0360 Hampton Pools
High Street
Hampton
TW12 2ST

**Planning Condition NS09
Arboricultural MS**

NS09 ARBORICULTURAL METHOD STATEMENT & TREE PROTECTION PLAN**Submission in response to
Condition U0120581 Arboricultural Method Statement and
Tree Protection Plan**

Extract from Tree Protection Plan showing Trees along the car park boundary

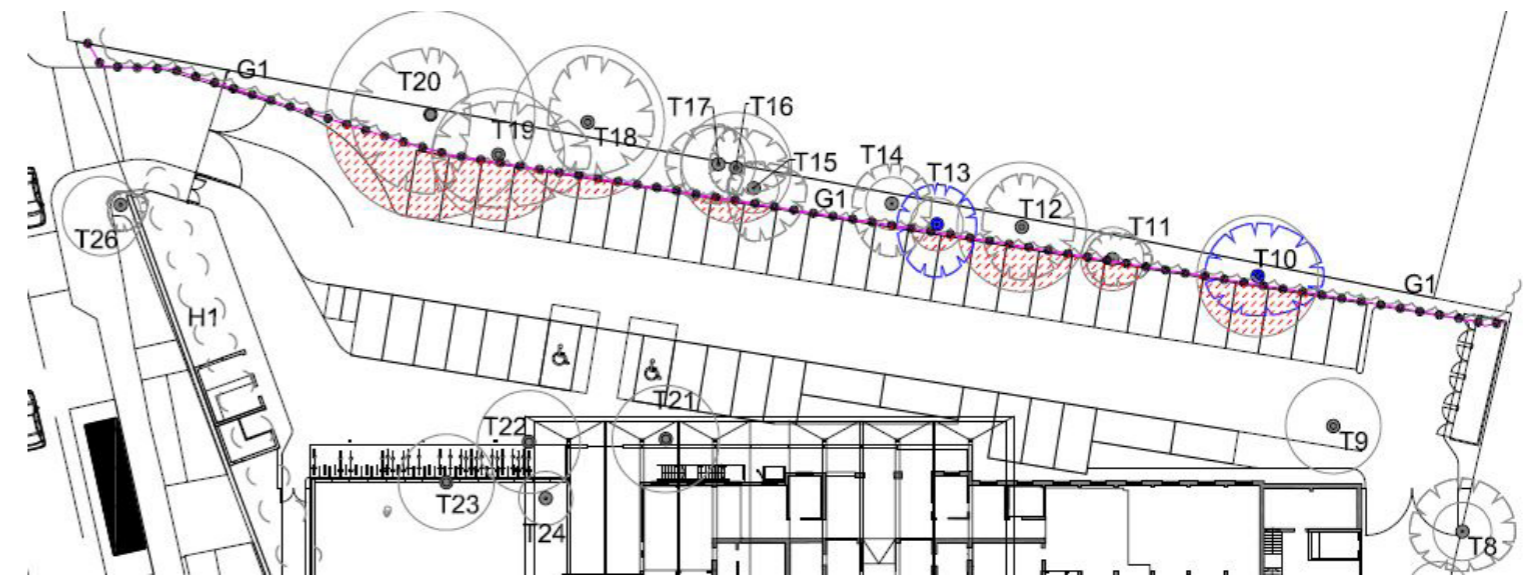
The submission is not thought to contain sufficient details of tree protection measures. Most of the trees on the site are along the boundary of the car park which is due to be resurfaced as well as part of the construction site.

It is also noted that the Root Protection Area of some of the trees is not covered by the protective fencing but will be subject to groundwork. It is thought, therefore, that details of underground services, ground protection measures and site-specific tree protection measures do need to be supplied in order to discharge the condition.

The report from Arboricultural consultant Canopy Consultancy: (File reference: 16-408-Report-Rev-A) states the following on the root protection areas in the car park area, including a methodology on how they will remain unaffected:

- The following trees will be affected by resurfacing the existing car park. Where the resurfacing within the RPA of a retained tree is proposed, the existing sub base is to be retained and reused. The existing wearing course is to be removed in accordance with the methodology described in Section 5.2 below:

T10, T11, T12, T13, T14, T15, T16, T18, T19 and T20

Where the existing wearing surface is proposed to be removed from within the RPA of T10, works will be carried out under the supervision of a suitably qualified arboriculturist. The existing wearing course will be broken up using hand operated tools and removed by excavator with a toothless bucket. The excavator will remain on the hard surface at all times and retreat away from the trees as the wearing course is removed. When the area is to be resurfaced, the existing sub-base is to remain in place and be re-used. The new wearing course will be laid immediately after the existing is removed.

No materials or spoil is to be stored within the RPA of a retained tree.
